DRAINAGE REPORT

PROJECT: 22A267

PCD File No. PPR2325

**Town of Ramah Wastewater
System Improvements**

PROPOSED DRAINAGE PLAN

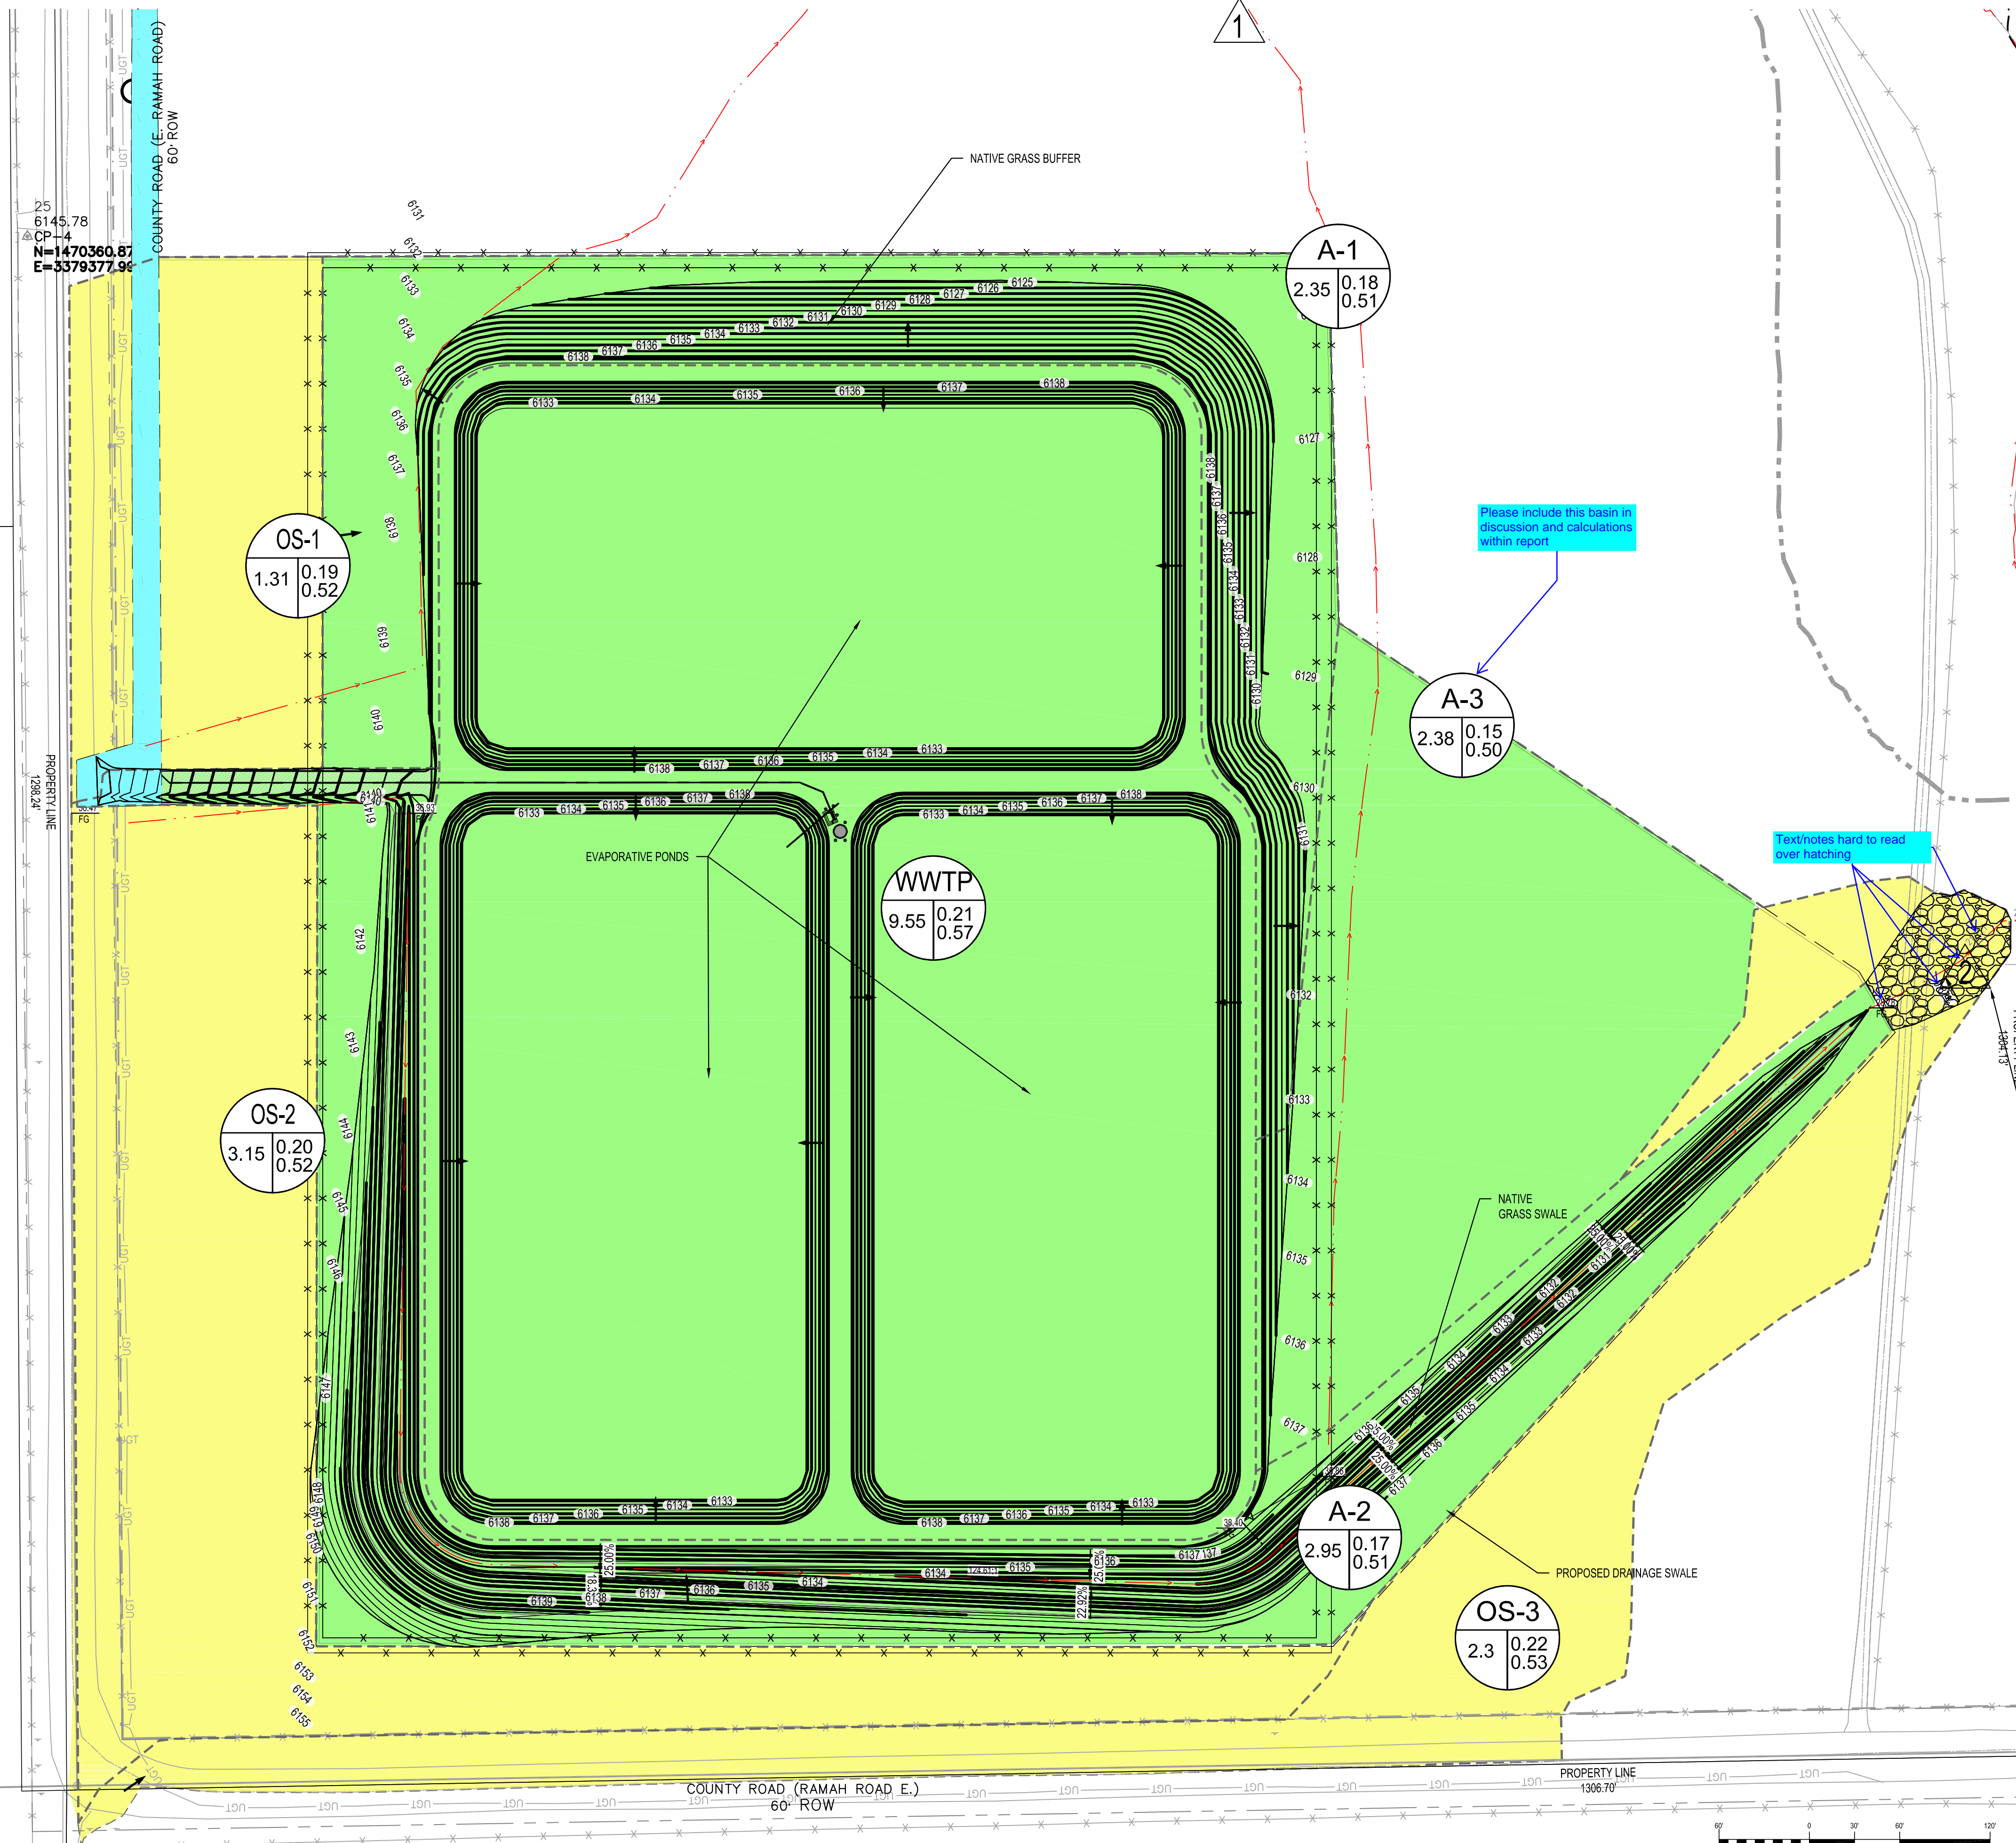
Drainage map shows a Basin A-3. Please include in discussion & calculations or remove from map.

Drainage map shows a Basin A-3.
Please include in discussion &
calculations or remove from map.

Drainage map shows a Basin A-3. Please include
in discussion & calculations or remove from map.
